CRMC DECISION WORKSHEET

2023-04-094

STATE OF RHODE ISLAND
COASTAL RESOURCES MANAGEMENT COUNCIL
STAFF REPORT TO THE COUNCIL
ADDENDUM

Applicant's Name:	Department of Transportation
CRMC File Number:	2023-04-094
Project:	Reconstruct "East Bay Bike Path Bridges" over the Barrington and Warren (Palmer) Rivers
Location:	Barrington/Warren East Bay Bike Path Bridges
Water Type/Name:	Type 1, 2, & 3; Barrington & Warren Rivers
Coastal Feature:	Coastal Wetland, Coastal Bluff with Rip Rap
Plans Reviewed:	<u>"East Bay Bike Path Bridge Replacements; Bike Path and Bridge Approach Plans; Reconstruction Plans, Environmental Permitting Set.."</u> Permit Plan Revisions February 2024 (Revised April 2024)... 26 sheets including cover sheet by RIDOT & VHB. Sheets 2-4 Last revised 12/22; Sheets 5-6, 11, 13-16, 20 & 24 Last revised 2/1/24; Sheet 19 last revised 4/17/24; sheets 7, 9, 10 & 18 last revised 4/18/24 and sheets 8, 12, 17, 21-23, 25-26 No date, no revision <u>"Reconstruction Plans, Environmental Permitting Set.."</u> Permit Plan Revisions February 2024 Revised April 2024.... 38 Sheets including cover sheet by DOT & VHB. Sheets 1-6, 8, 15, 17, 18, 23, 25-31, 33 and 35-38 no date, no revision;

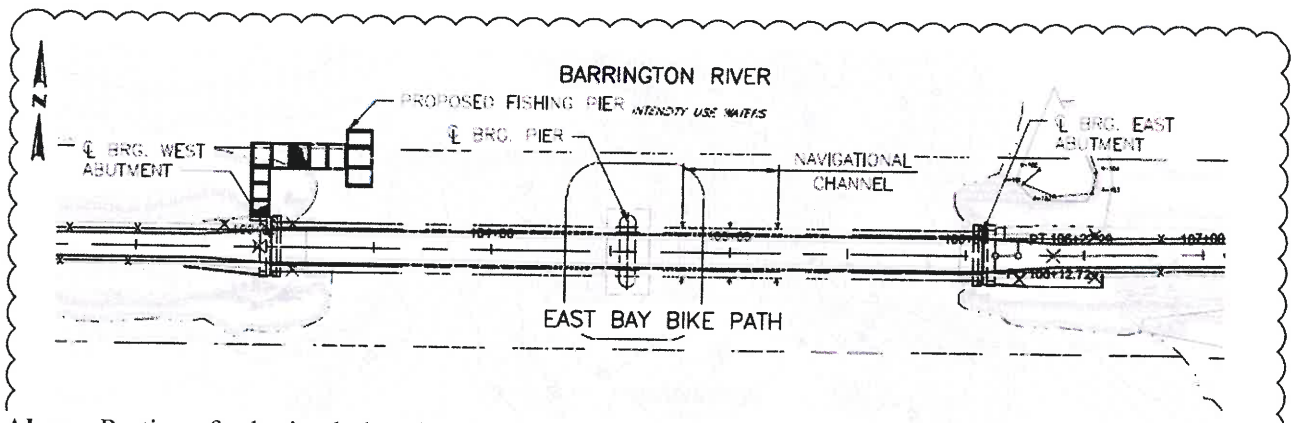
Fishing Impacts- Fishing and the impacts to the existing fishing along both bike path spans has been a topic of discussion for multiple years, as the subject came up in several pre-application meetings with CRMC. The design for both the bike path spans remains 14 feet wide, with a 10

foot wide bike path and two (2) foot width on either side. It remains unclear if that two (2) foot area would be utilized for the truss support systems. Regardless, the design likely will not safely provide access for fishing along the spans of the bridges.

The DOT has stated that the width is driven by the limitations of the pre-fabricated structures as well as the existing overhead wires and challenges involved with installation. The application narrative states “Additional widening would require a substantial volume of fills in tidal waters, particularly given the increased bridge heights, and would introduce fills to coastal wetland previously. The added weight of a widened bridge would necessitate an additional pier in the river and preliminary cost estimates to widen the bridges would far exceed the project budget” [sic].

Above: Portion of submitted plan showing the proposed timber pier on the Barrington River

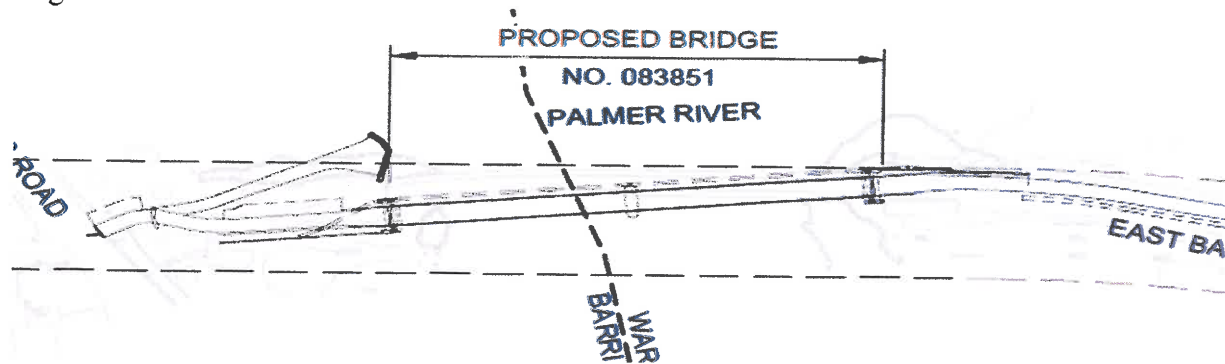
On the Barrington River, a pile supported timber fishing pier is proposed, located on the western bank, north of the bike path. On the Palmer/Warren River, the temporary bulkhead on the western side of the River, also north of the bike path, is proposed to remain permanently with minor improvements for long term viability.

The retention and modification of the bulkhead for fishing access will require 668 cubic yards of permanent fill in tidal waters. Filling in Type 2 waters is prohibited under § 1.3.1(J)(3)(a) and this proposed fishing access requires a special exception.

“Red Book” Section 1.3.6(A)(3) states: *“It is the Council’s policy to require applicants to provide, where appropriate, on-site access of a similar type and level to that which is being impacted as the result of a proposed activity or development project”*. Staff is unable to determine if the two proposed fishing access structures will indeed allow access to the deepest portions of the rivers or provide commensurate access on both incoming and outgoing tides.

Fishing off the Warren/Palmer River span, clearly showing “sidewalks” (Photo: www.trailink.com)

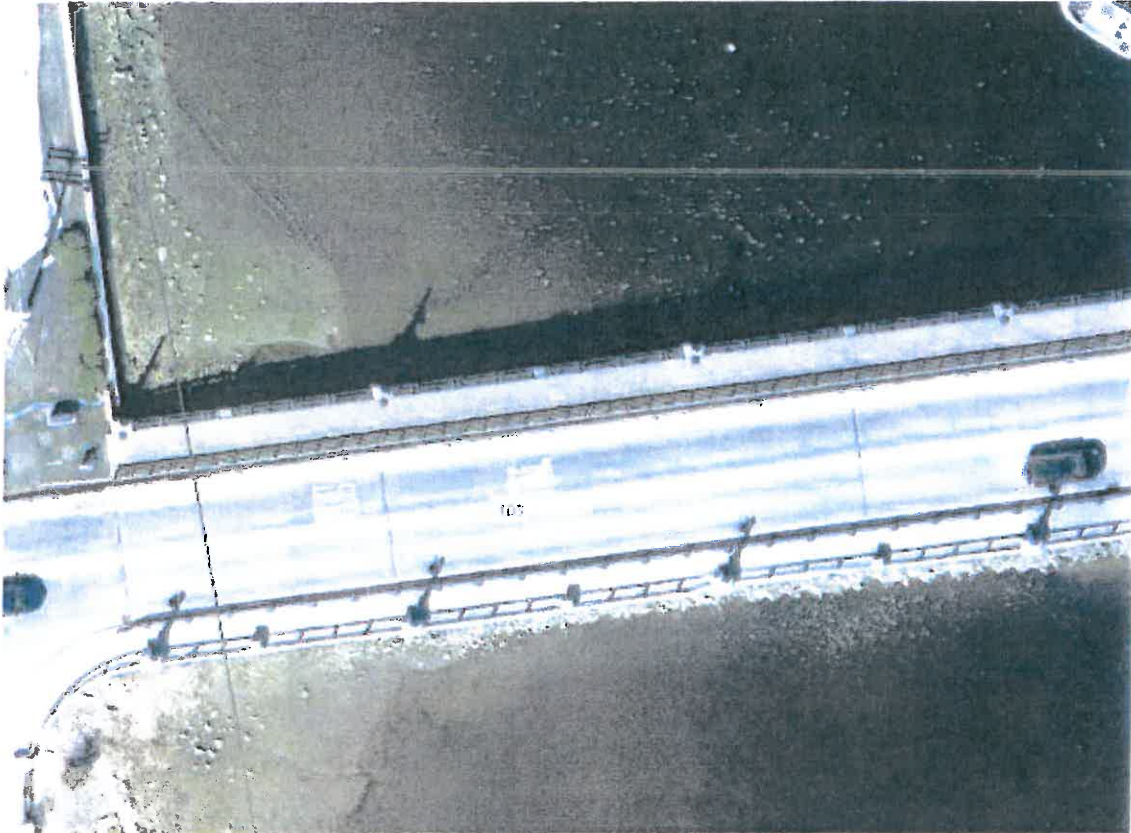
The cover letter proceeds to note that the new bridges will not provide “dedicated fishing access”, but fishing will not be prohibited. It should be noted that the previous bridges did not provide dedicated access either. They had “sidewalks” on either side of the dedicated bike path that was utilized. It appears that sidewalks are part of the newly proposed bridges as well, although they appear narrower than previous. CRMC staff further questioned the applicant and DOT officials for clarity about sidewalks on the bridge structures themselves and was told that there is a two-foot wide area on either side of the bike path.

CRMC followed up requesting additional information, as the two-foot area appears to be narrower than what was provided on the previous structures, and it is unclear how that two-foot area will be utilized with the truss/overhead structures. To date, no response has been submitted.
